Site Accessibility Evaluation

Administration Building

913 S Dubuque St
Iowa City, IA 52240

Inspection Date: 11/27/2018
Inspector: Shelley Zuniga

Finding: 4

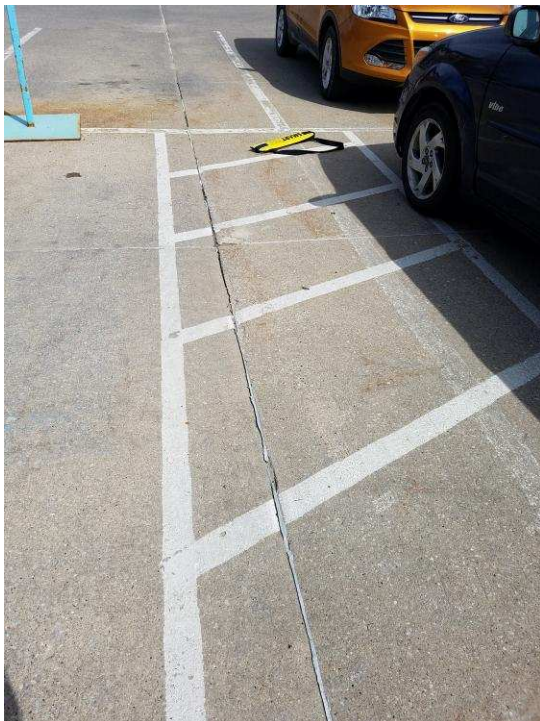
The parking stall contains abrupt edges and surface irregularities over a 1/4 inch vertical.

public lot - large crack
in access aisle 1" CIL
in valve cover in aisle;
signage not fixed and
overlap stall space

Resurface stalls and access aisles to eliminate gaps and cracks; install permanent signage to eliminate overlap into stalls

Finding: 6

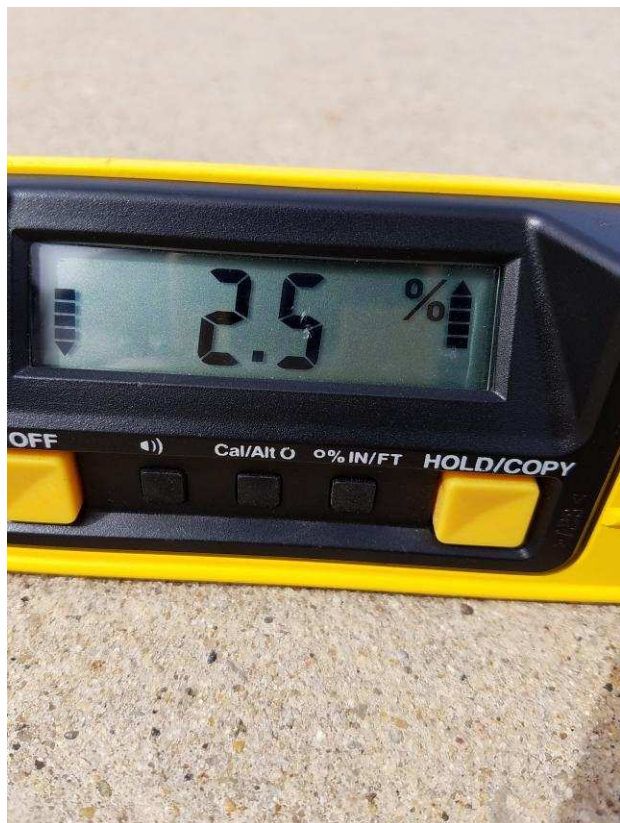
The cross slopes (narrow dimension) and/or running slopes (long dimension) of the accessible stall exceeds 2%.

2.5% in 6th stall

Correct or repair slope of stall to max 2.08% in any direction

Finding: 15

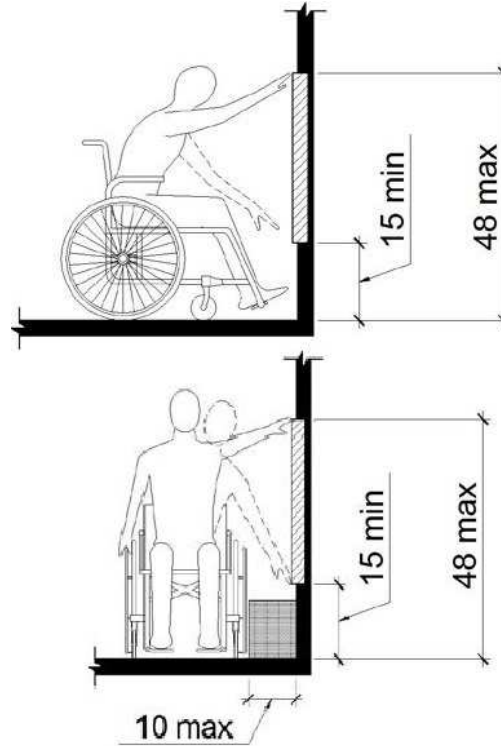
The brochure rack is positioned too high for either a side or front approach.

brochure rack in shelter at 61.5"

Remount operable parts to be in reach range of 15" min to 48" max

Finding: 18

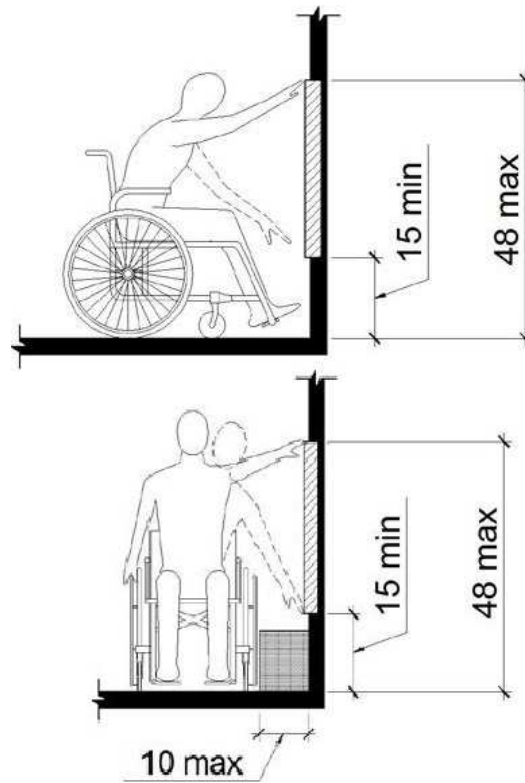
The AED is positioned too high for either a side or front approach.

59" to AED handle

Remount operable parts to be in reach range of 15" min to 48" max

Finding: 21

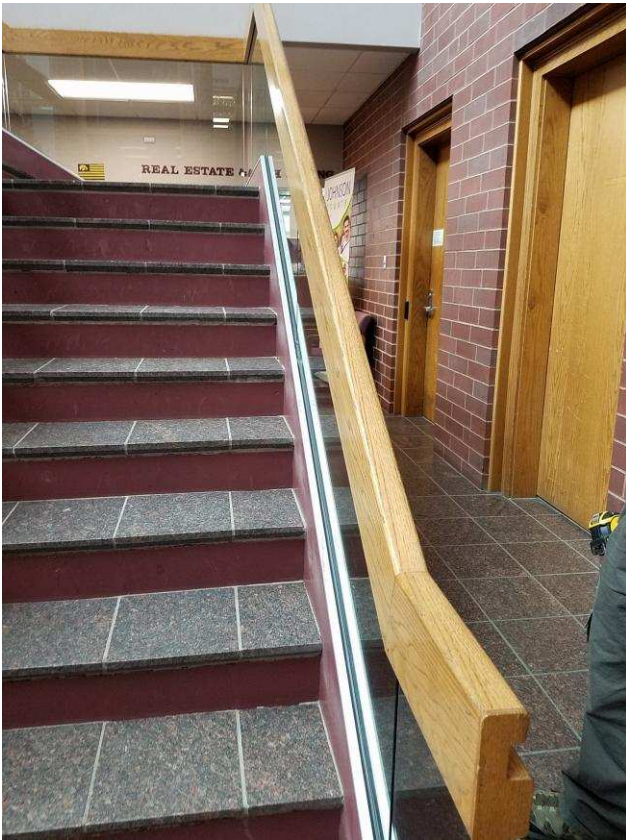
Stairways must have handrails on both sides.

main stairway,
handrail fails

Install handrails on both sides of stairway, mounted 34" to 38" aff with top and bottom extensions and having a 1.25" – 2" in diameter, or a non-circular grip that has a perimeter dimension of 4"- 6.25" max with a min gap of 1.5" between handrail and wall

Finding: 23

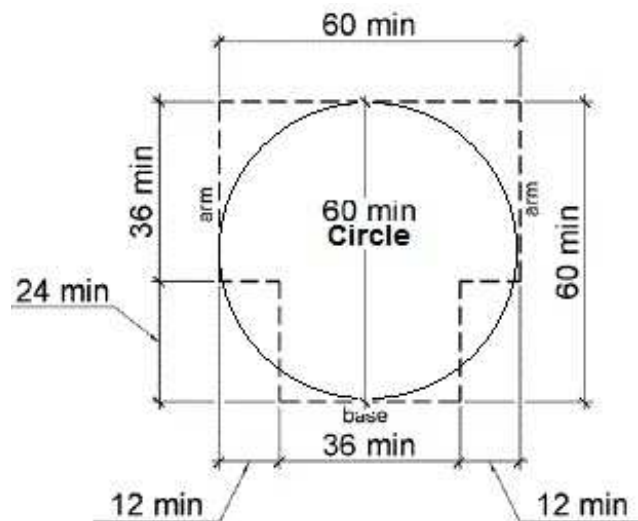
There is insufficient turning space within this room or space.

Janitor - too small

For deficit, leave as is, employee work area pursuant to 2010 Standards 106.5 Defined Terms, until an employee with a disability works here

Finding: 25

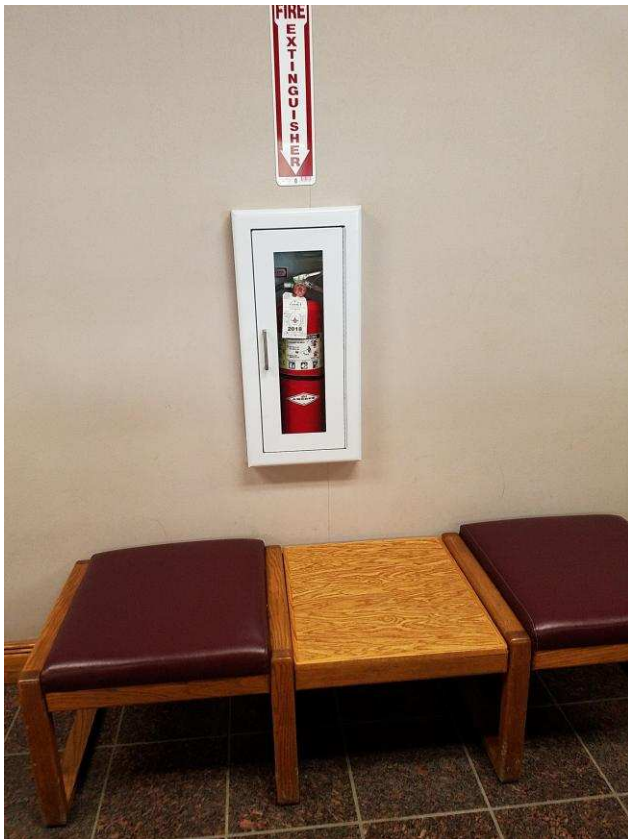
The fire extinguisher is not accessible because there is not adequate clear floor space for either a forward or side approach.

bench at fire extinguisher near treasurer

Remove, or relocate storage in CFS at fixtures and operable parts along the AR

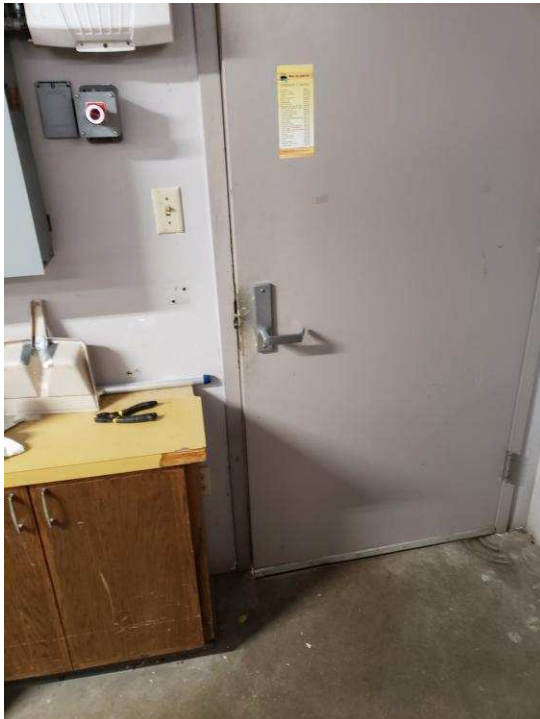
Maint office from
treasurer - 11 lbs push,
shelf on pull

For all doors along the public circulation route, provide required maneuvering clearance on push and pull side of doors

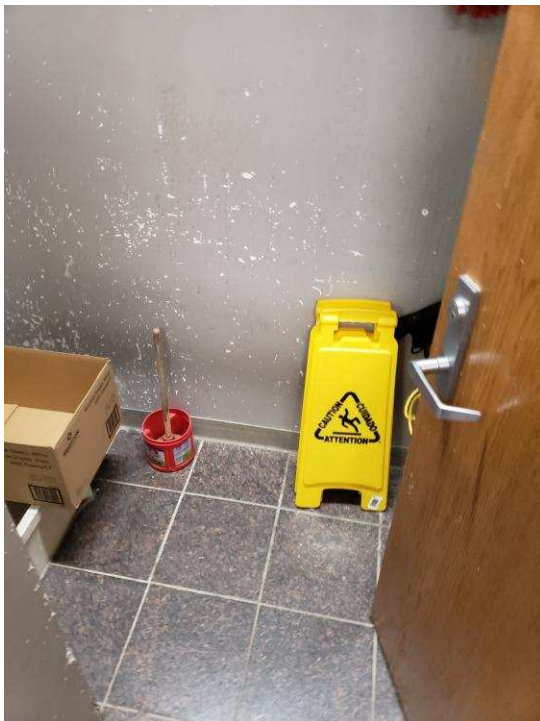
janitor closet - 11 lbs
push, storage on pull

For all doors along the public circulation route, provide required maneuvering clearance on push and pull side of doors

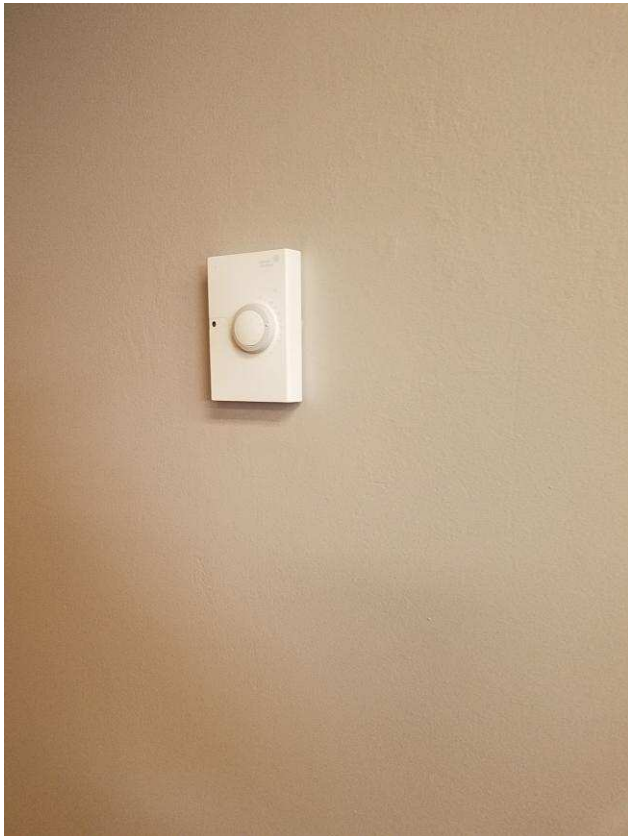
Planning main room -
thermostat knob, back
tstat no CFS

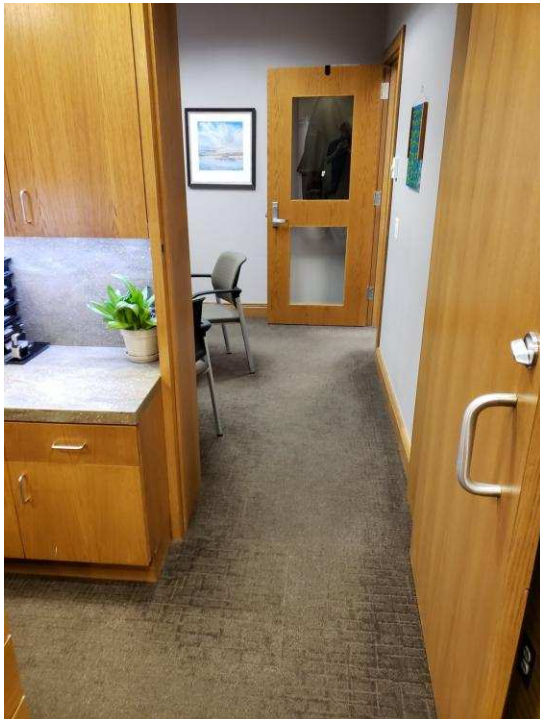
Mike H to entry -18 lbs
push, shelf on pull,
chair on push

For all doors along the public circulation route, provide required maneuvering clearance on push and pull side of doors
